HEALTH OFFICER DECISION

Application Type: Building Site Application - New

11143 ROLLING BAY WALK NE Bainbridge Island WA 98110

REVISION REQUEST FORM

KCDCD - ENVIRONMENTAL CURCLIST TAX LOT No. 4166-001-004-1066

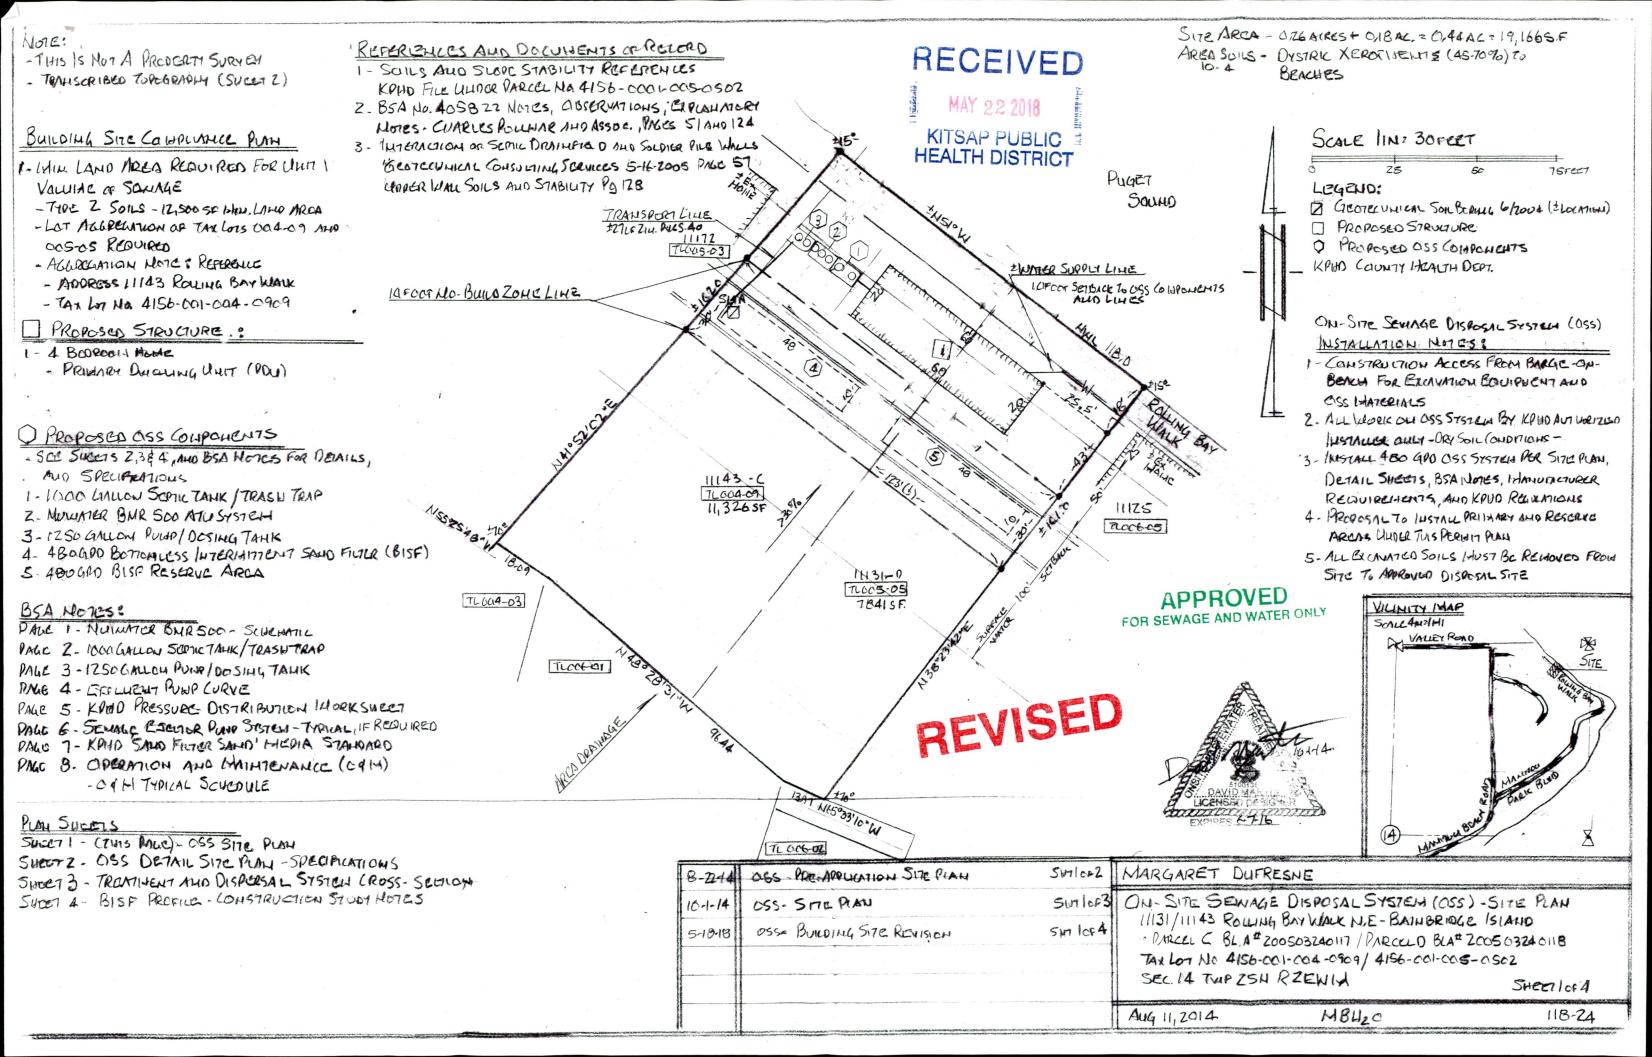
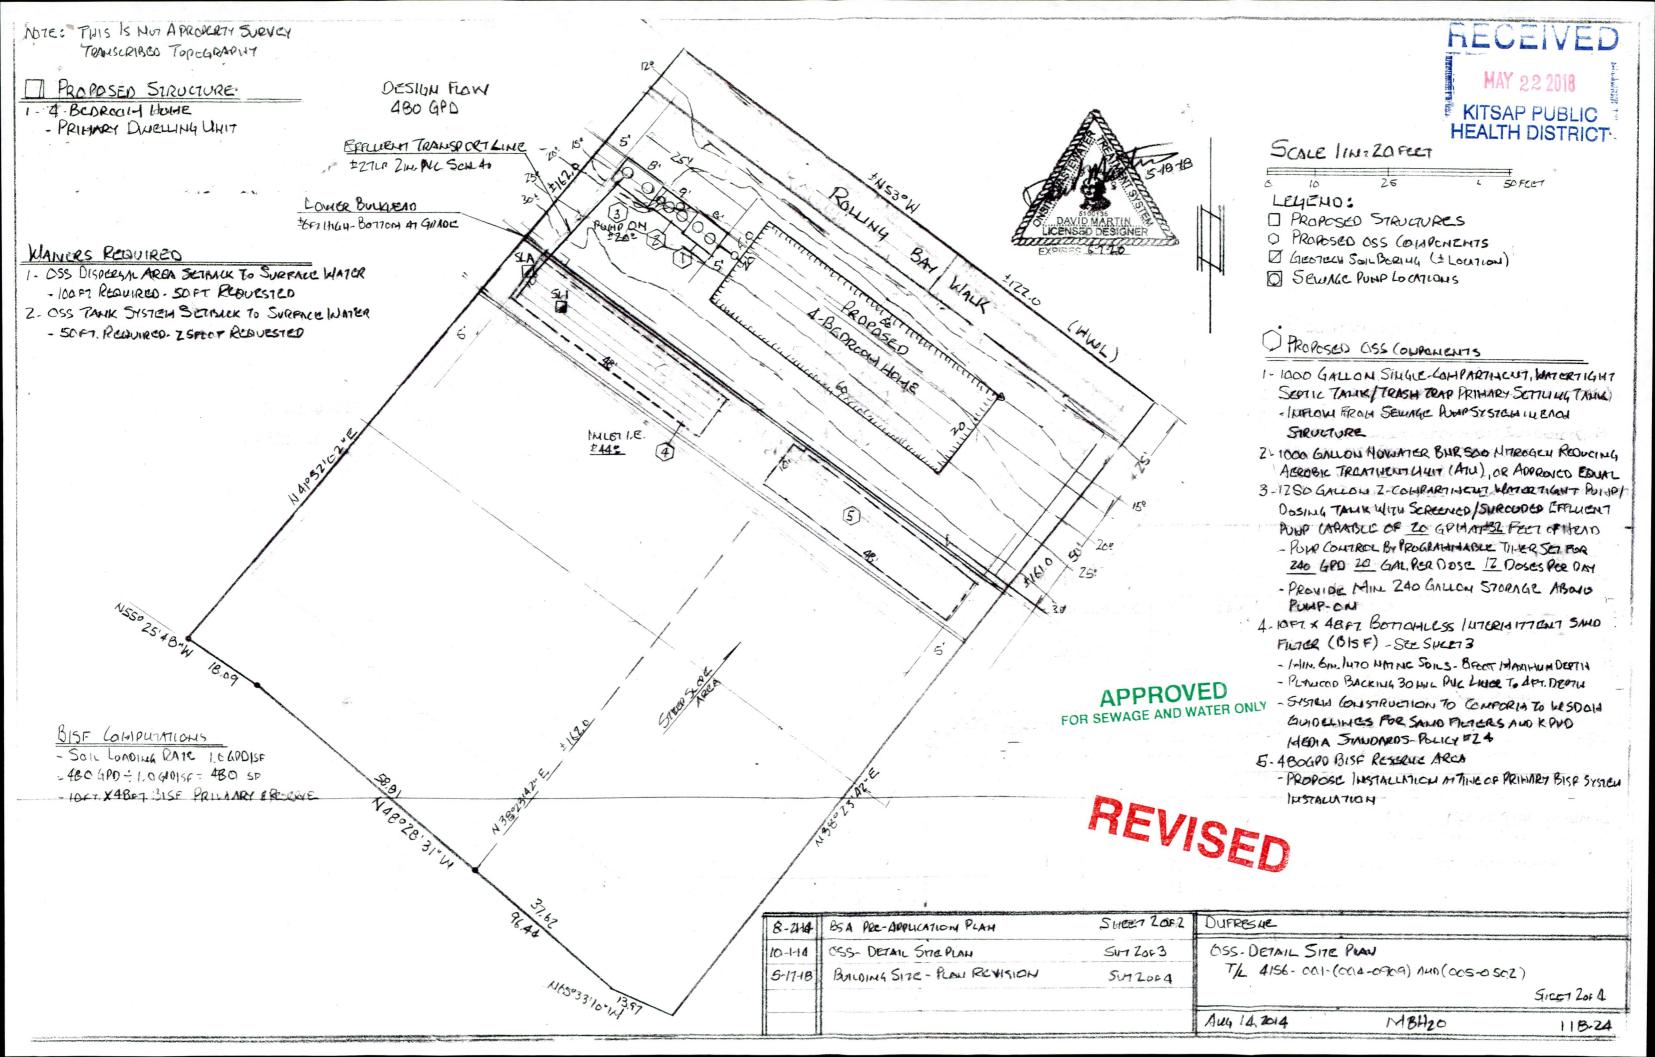
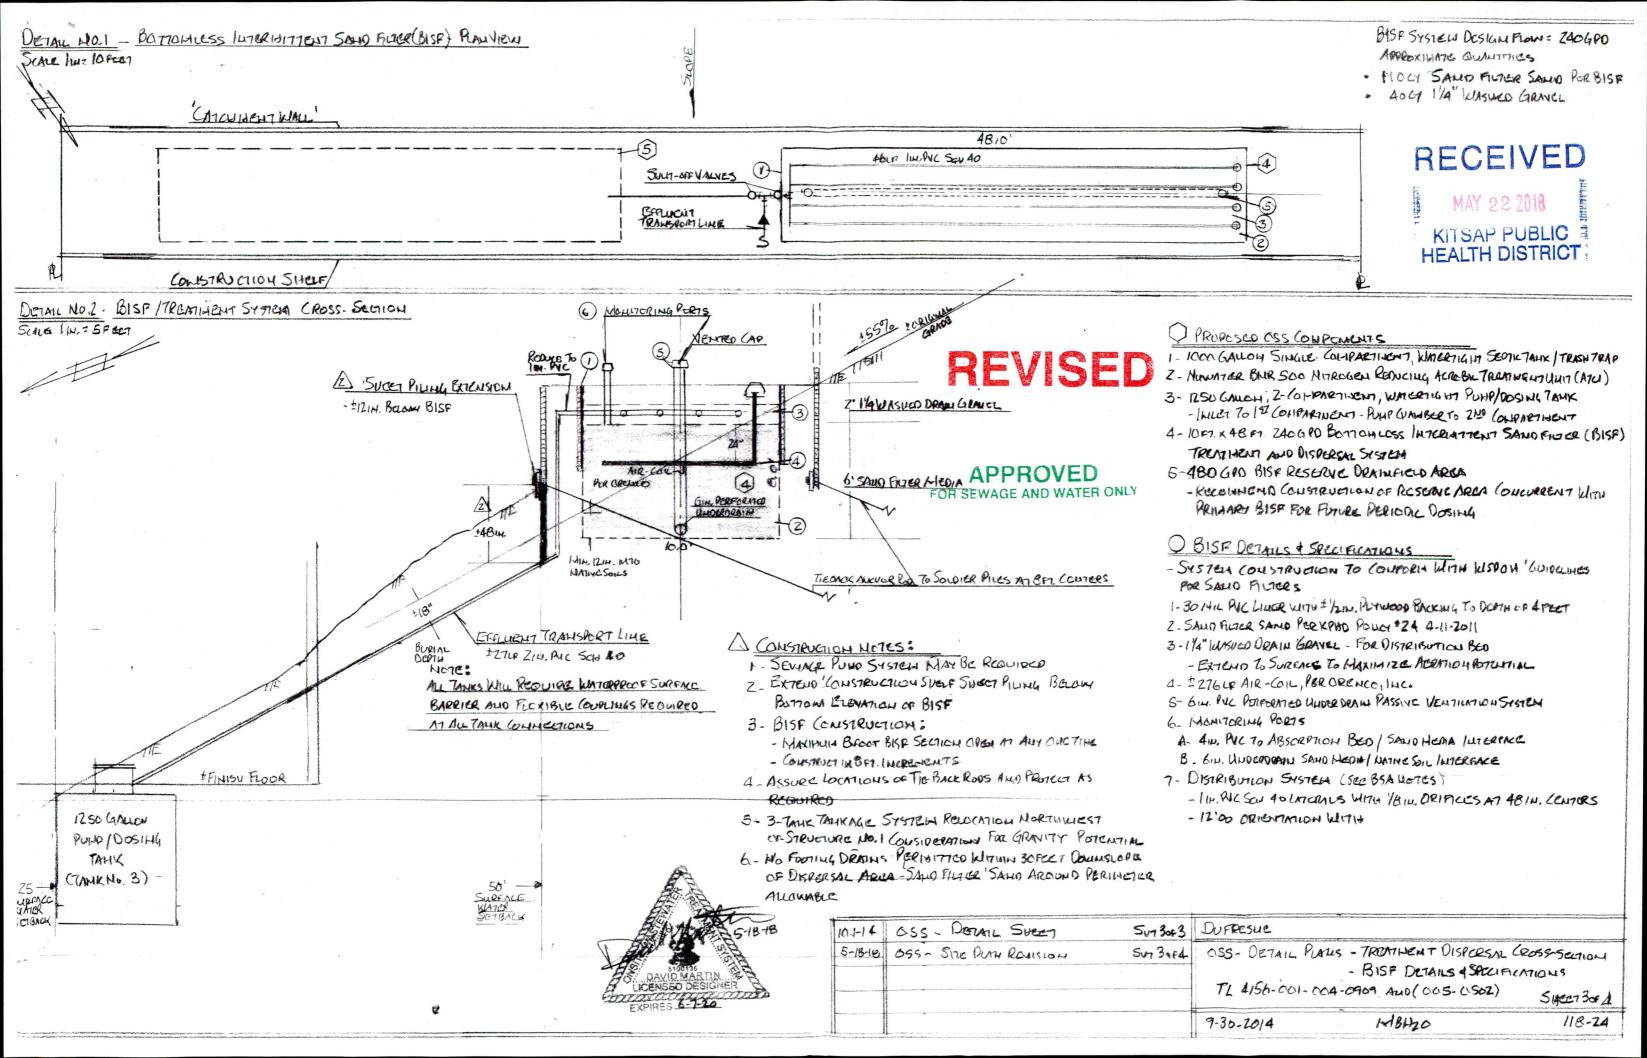
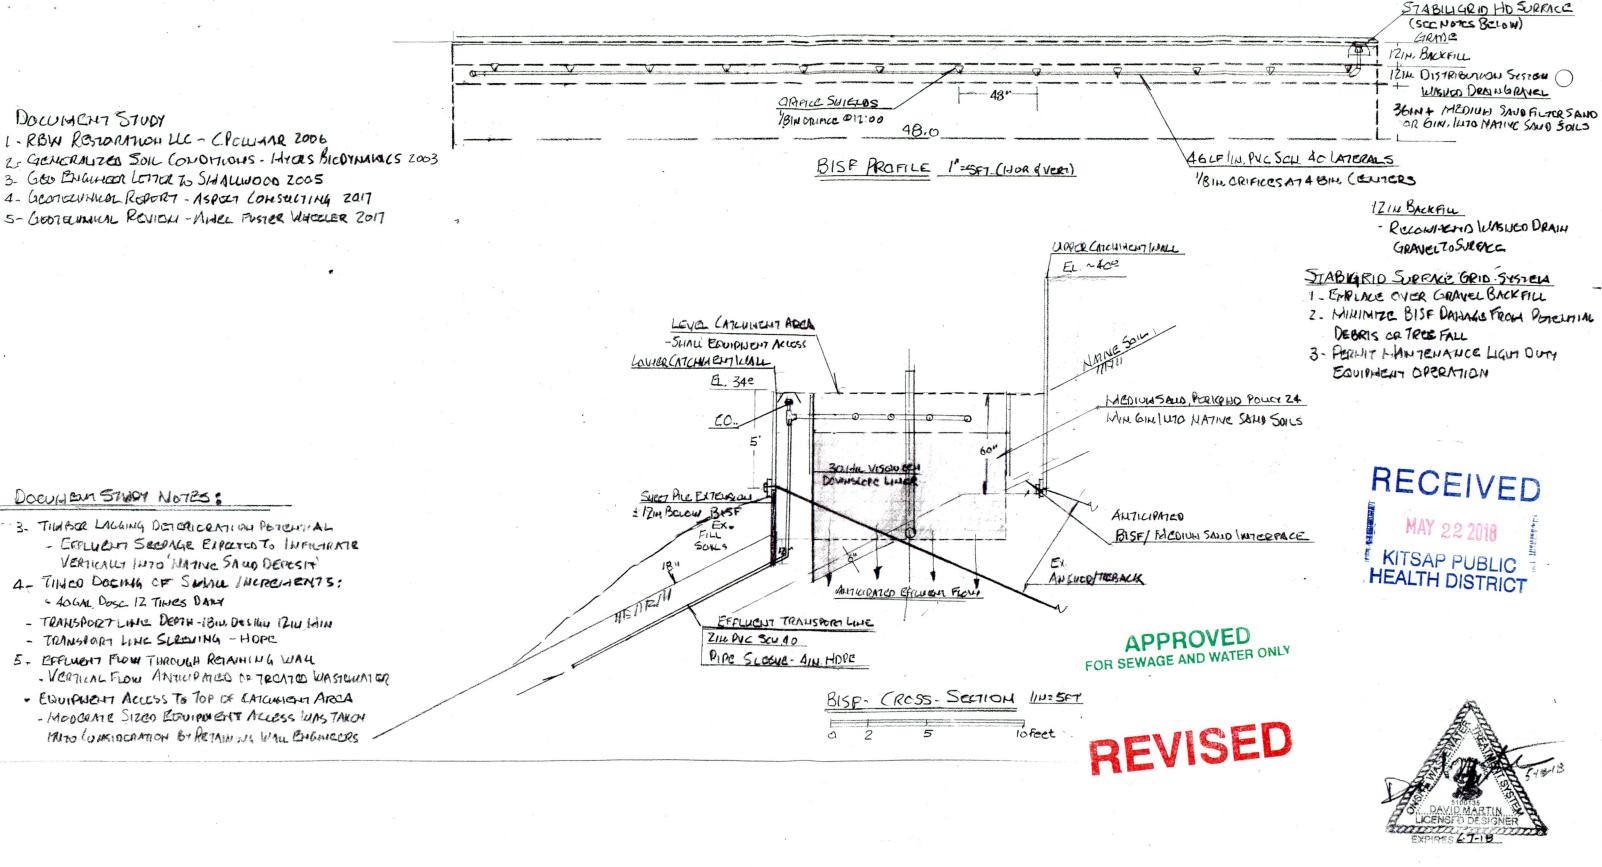
1.1	
BSA MEHO Na 318627 scribe minor revision in detail:	
Kenuce Prous 2 Dimannia Unio 7.	6 1 4-BEORCON DWELLING UNIT
-TMIX PRIACEDIA, PROMICEO	- No OTHER OSS REVISIONS REQUIRED
MARKETON TON REGULATED	THO DIVER USS REVISIONS RECOUNTERLY
and the second s	
Enclosures: Sweets 1-2-	3-4
	CUECKUSTAPPROVED
	CUECKLISTAPPROVED FOR SEWAGE AND WATER ONLY
	CUECKUSTAPPROVED
Size PLAN C	FOR SEWAGE AND WATER ONLY
	FOR SEWAGE AND WATER ONLY
Size PLAN C	FOR SEWAGE AND WATER ONLY
Size PLAN C	FOR SEWAGE AND WATER ONLY
Size PLAN C	FOR SEWAGE AND WATER ONLY 5-24-18 DANIP MARTIN EXPIRES 61-20
Size PLAN (FOR SEWAGE AND WATER ONLY
Size PLAN C	FOR SEWAGE AND WATER ONLY 5-24-18 DANIP MARTIN EXPIRES 61-20
Size PLAN C	FOR SEWAGE AND WATER ONLY 5-24-18 DANIE DESIGNER EXPIRES 6-1-40
Size Pease of Parlawed + Approved	FOR SEWAGE AND WATER ONLY 5-24-18 DANIP MARTIN EXPIRES 61-20
Site PLAN (FOR SEWAGE AND WATER ONLY 5-24-18 DANIP MARTIN EXPIRES 61-20
